# International Aero Engines SERVICE BULLETIN

ENGINE - FUEL AND CONTROL - INTRODUCE NEW FUEL PUMP TO FUEL  
COOLED OIL COOLER TUBES WITH A REPOSITIONED RESTRICTOR ORIFICE

73-00-00

# V2500-ENG-73-0058

Location of clipping points 0302, 0304, 0305, 0306 and 0319  
Figure 1

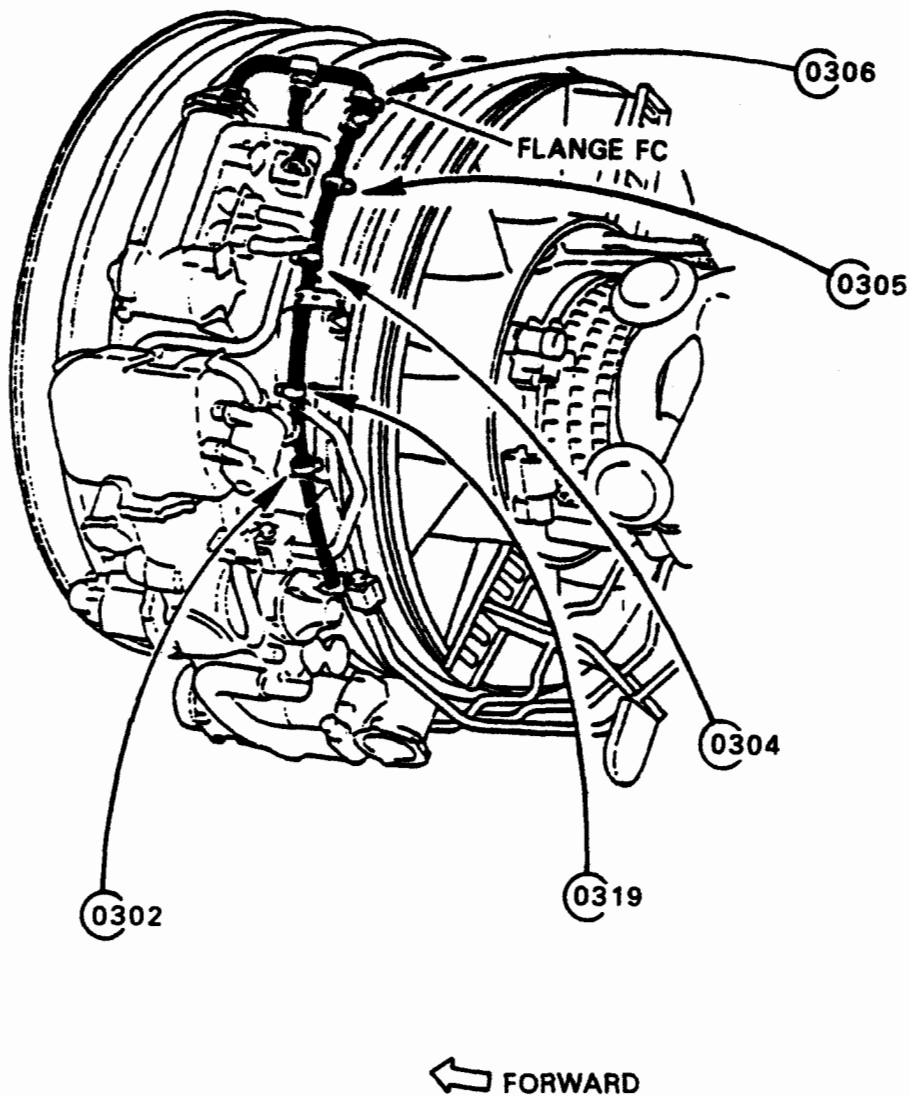
- (1) Disassemble clipping points 0302, 0304, 0305, 0306 and 0319 sufficiently to remove the 6A5340 (SBE 73-0045) or 2A0616 (pre SBE 73-0045) fuel tube assembly. Refer to Figures 1 and 2.

**Schematic view of fuel tubes - Before and after alteration  
Figure 2**

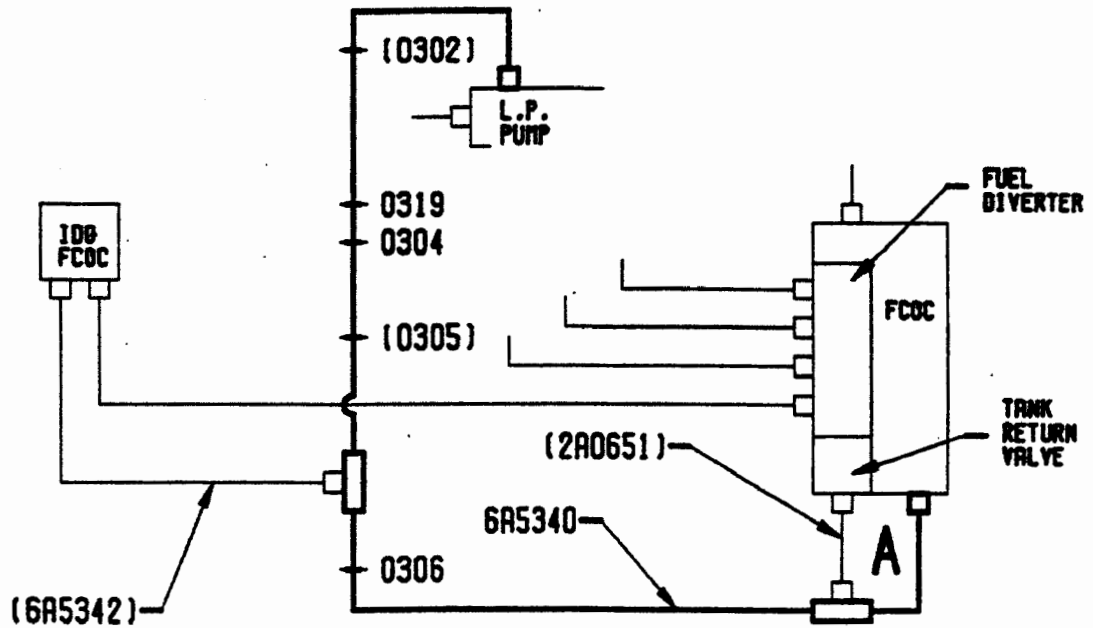
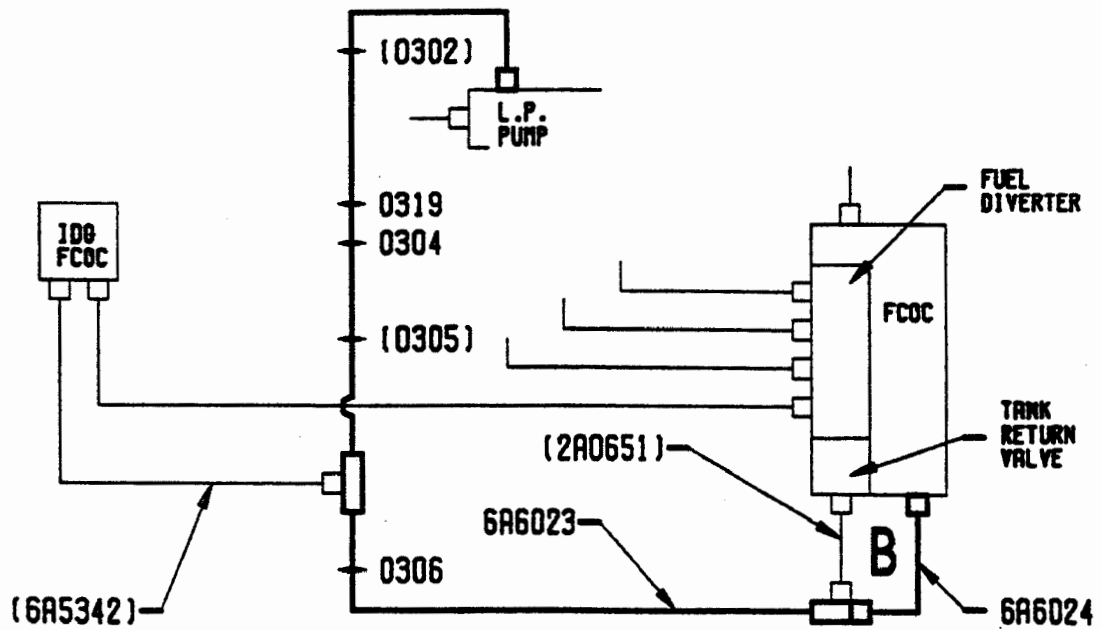
The existing L.P. fuel pump to F.C.O.C. fuel inlet tube assembly is replaced by two tube assemblies. The first tube runs from the L.P. fuel pump to the connector for the return to tank valve tube and the second tube runs from this connector to the F.C.O.C. fuel inlet. The fuel flow restrictor has been redesigned to prevent incorrect assembly and its location changed from the F.C.O.C. inlet end of the existing tube to the return to tank valve tube connector end of the new F.C.O.C. fuel inlet tube. Clipping Points 0304, 0306 and 0319 have been modified to accommodate the new tube. Clipping Points 0304 and 0319 have had spacers added and Clipping Point 0306 has been moved forward from the rear face to the front face of its existing bracket.

- (2) Remove the bolts attaching the 6A5340 (SBE 73-0045) or 2A0616 (pre SBE 73-0045) fuel tube to the LP fuel pump and the F.C.O.C. Disconnect the union between the 2A0651 and 6A5340 fuel tubes using an IAE 1R18003 wrench. Disconnect the union between the 6A5342 (SBE73-0045) or 2A0649 (pre SBE 73-0045) fuel tube and the 6A5340 (SBE 73-0045) or 2A0616 (pre SBE 73-0045) (SBE 73-0045) or 2A0616 (pre SBE 73-0045) fuel tube and remove the 6A5340 (SBE 73-0045) or 2A0616 (pre SBE 73-0045) fuel tube. Refer to Figure 2.

View at A (see Figure 2) - Before alteration  
Figure 3

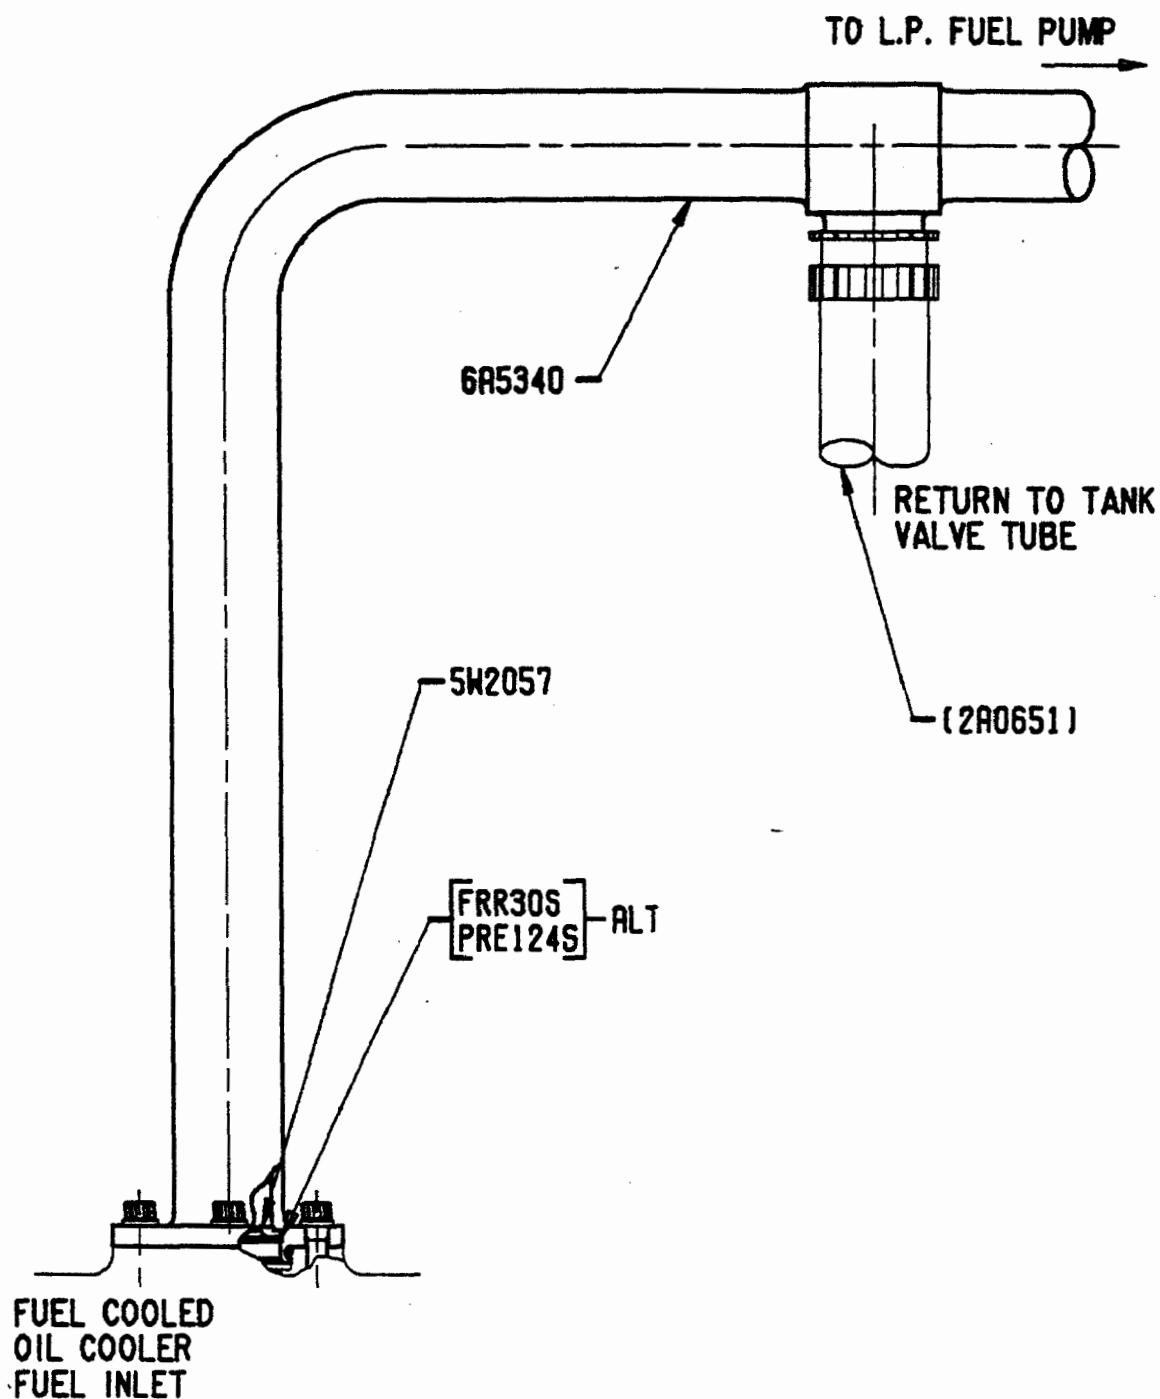
- (3) Remove the sealing rings, the FRR30S or PRE124S retainer and the 5W2057 restrictor from the 6A5340 (SBE 73-0045) or 2A0616 (pre SBE 73-0045) fuel tube. Discard the sealing rings. Refer to Figure 3.

View at B (see Figure 2) - After alteration  
Figure 4

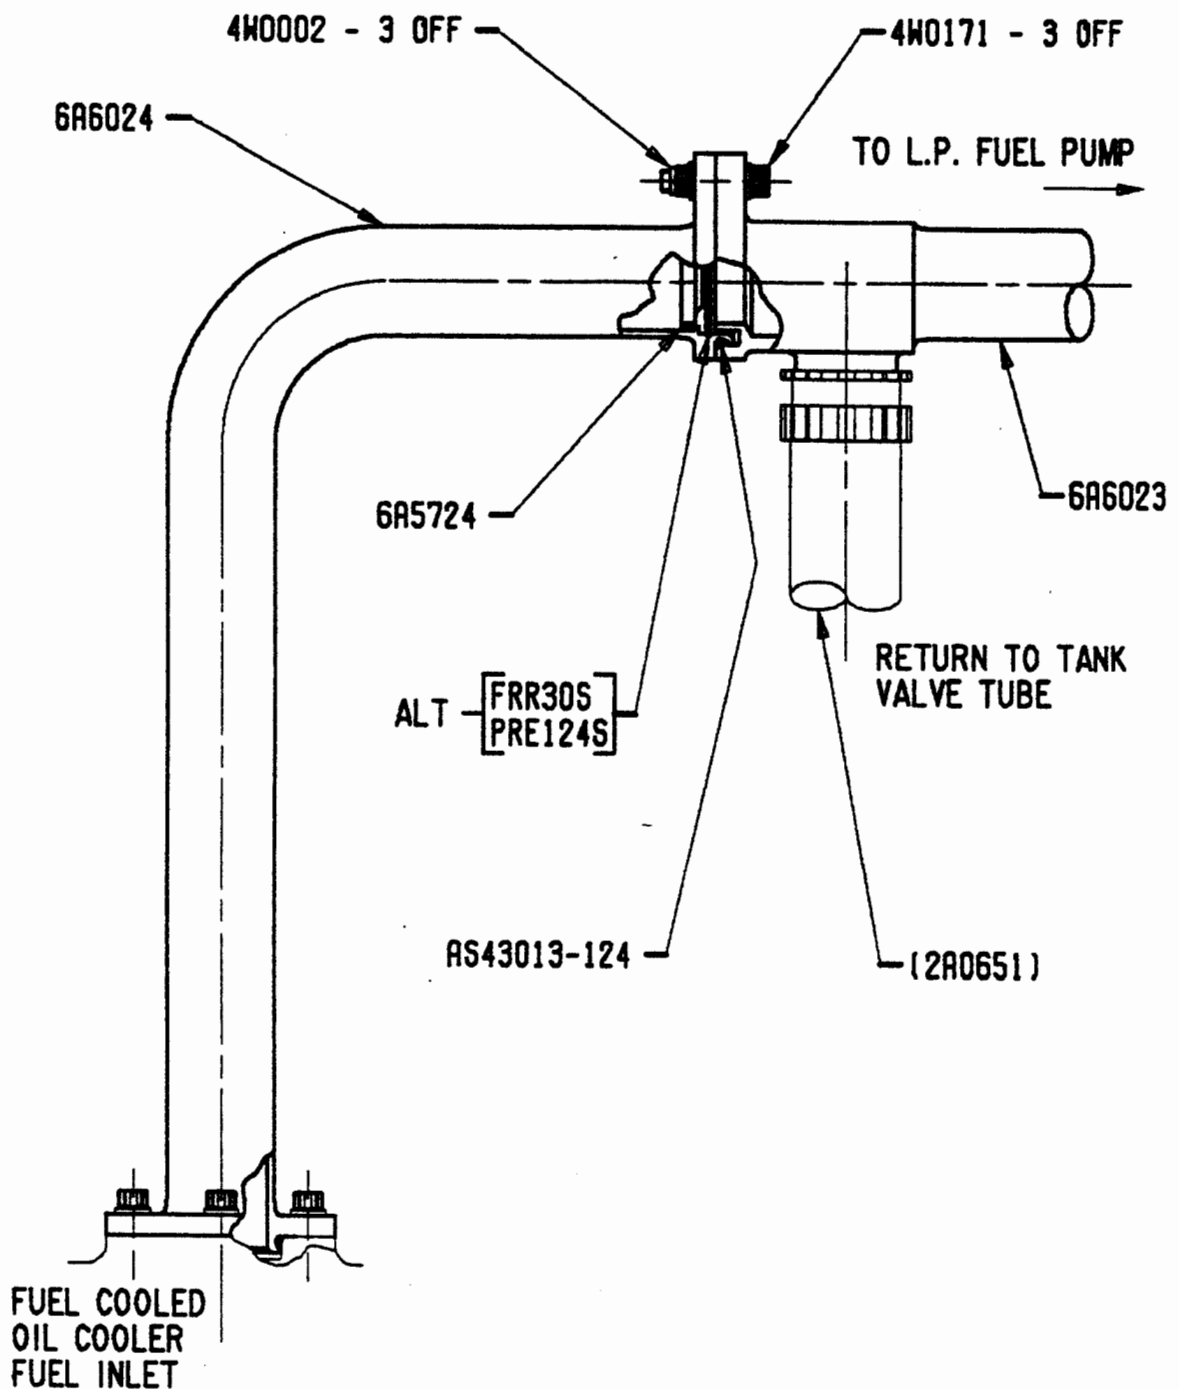
- (1) Install a new AS43013-124 sealing ring, lubricated with V10-038 Petroleum Jelly or V10-060 Liquid Paraffin (Reference (1), Chapter/Section 70-30-00), onto the 6A6023 fuel tube. Using the bolts removed at (2) install the 6A6023 fuel tube on to the LP fuel pump. Connect the 2A0651 fuel tube to the 6A6023 fuel tube and torque the union nut to 566 to 611 lbfin (64 to 69 Nm) using an IAE 1R18003 wrench. Connect the 6A5342 (SBE 73-0045) or 2A0649 (pre SBE 73-0045) fuel tube to the 6A6023 fuel tube and torque the union nut to 566 to 611 lbfin (64 to 69 Nm). Safety the tube union nut with V02-126 lockwire (Reference (1), Chapter/Section 70-30-00). Torque the bolts at the LP fuel pump to 85 to 105 lbfin (10 to 12 Nm). Refer to Figure 4.

- (2) Install the new 6A5724 restrictor, FRR30S or PRE124S retainer and two new AS43013-124 sealing rings lubricated with V10-038 Petroleum Jelly or V10-060 Liquid Paraffin (Reference (1), Chapter/Section 70-30-00), on to the new 6A6024 fuel tube. Connect the 6A6024 fuel tube to the 6A6023 fuel tube using the 4W0171 bolts (3 off) and 4W0002 nuts (3 off). Install the 6A6024 fuel tube on to the F.C.O.C. using the bolts removed at (2). Torque these and the 4W0171 bolts to 85 to 105 lbfin (10 to 12 Nm). Refer to Figure 4.

Clipping point 0304 - Before and after alteration  
Figure 5

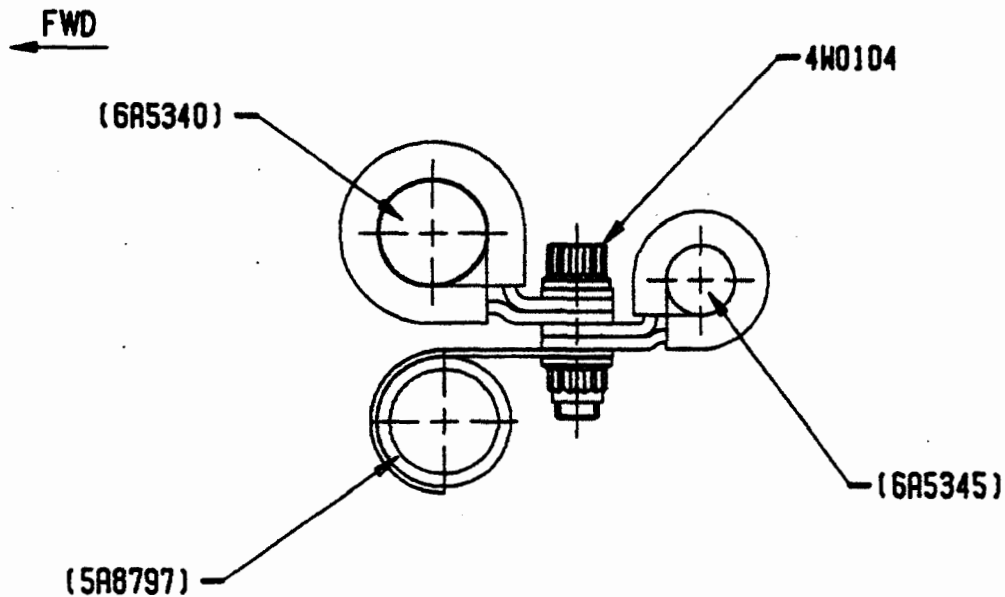
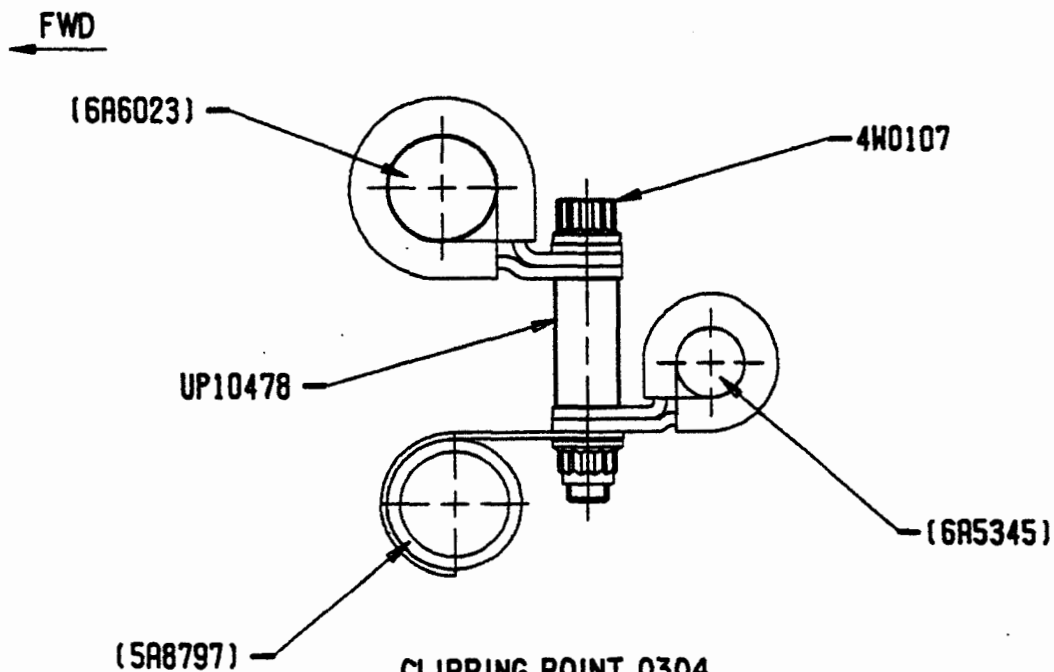
- (3) Reassemble clipping points 0302 and 0305 using the material removed at B.(1). Torque the bolts to 36 to 45 lbfin (4 to 5 Nm).
- (4) Reassemble clipping points 0304 and 0319 using the material removed at B.(1) and incorporating the new UP10478 spacers and 4W0107 bolts. Torque the bolts to 36 to 45 lbfin (4 to 5 Nm). Refer to Figures 5 and 7.

Clipping point 0306 - Before and after alteration  
Figure 6

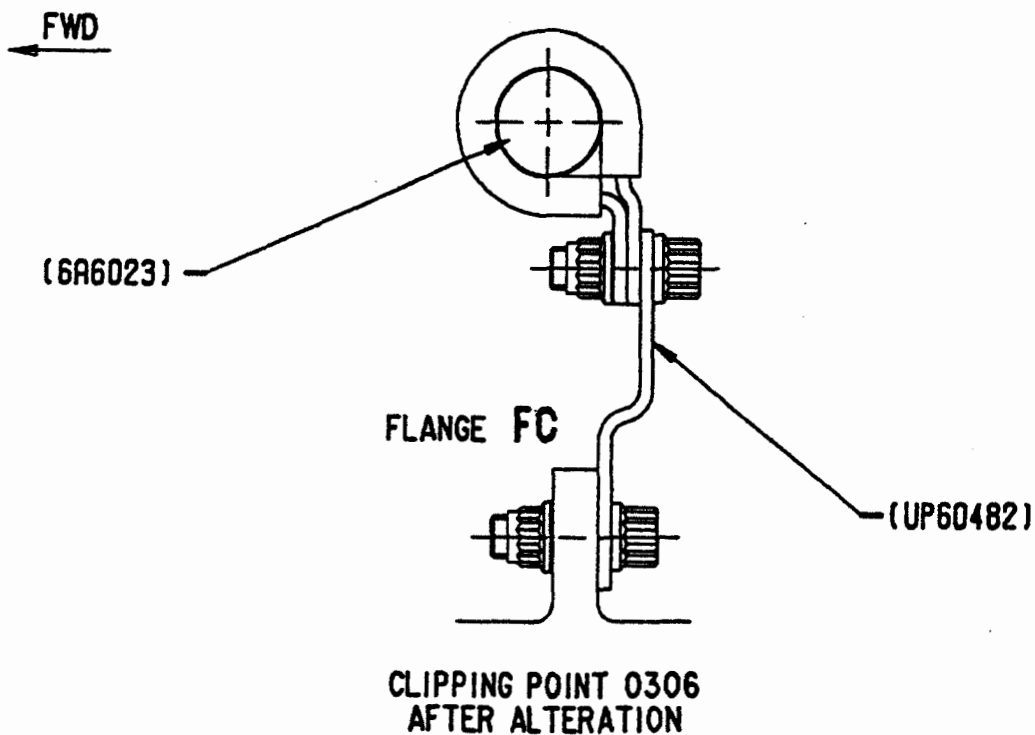
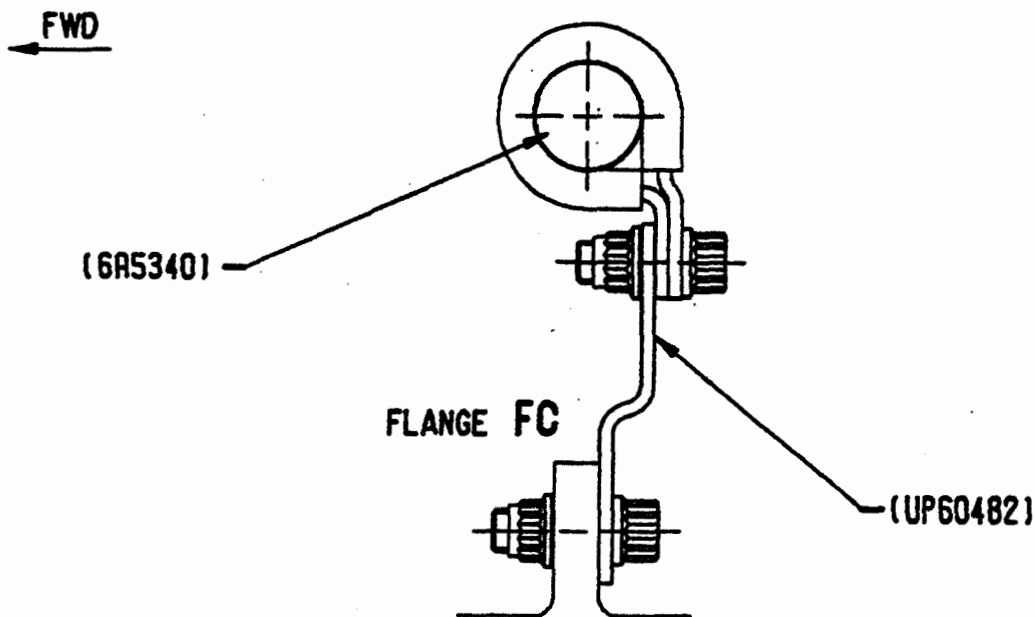
- (5) Reassemble clipping point 0306 on the forward face of the UP60482 bracket using the material removed at B.(1). Torque the bolt to 36 to 45 lbfin (4 to 5 Nm). Refer to Figure 6.
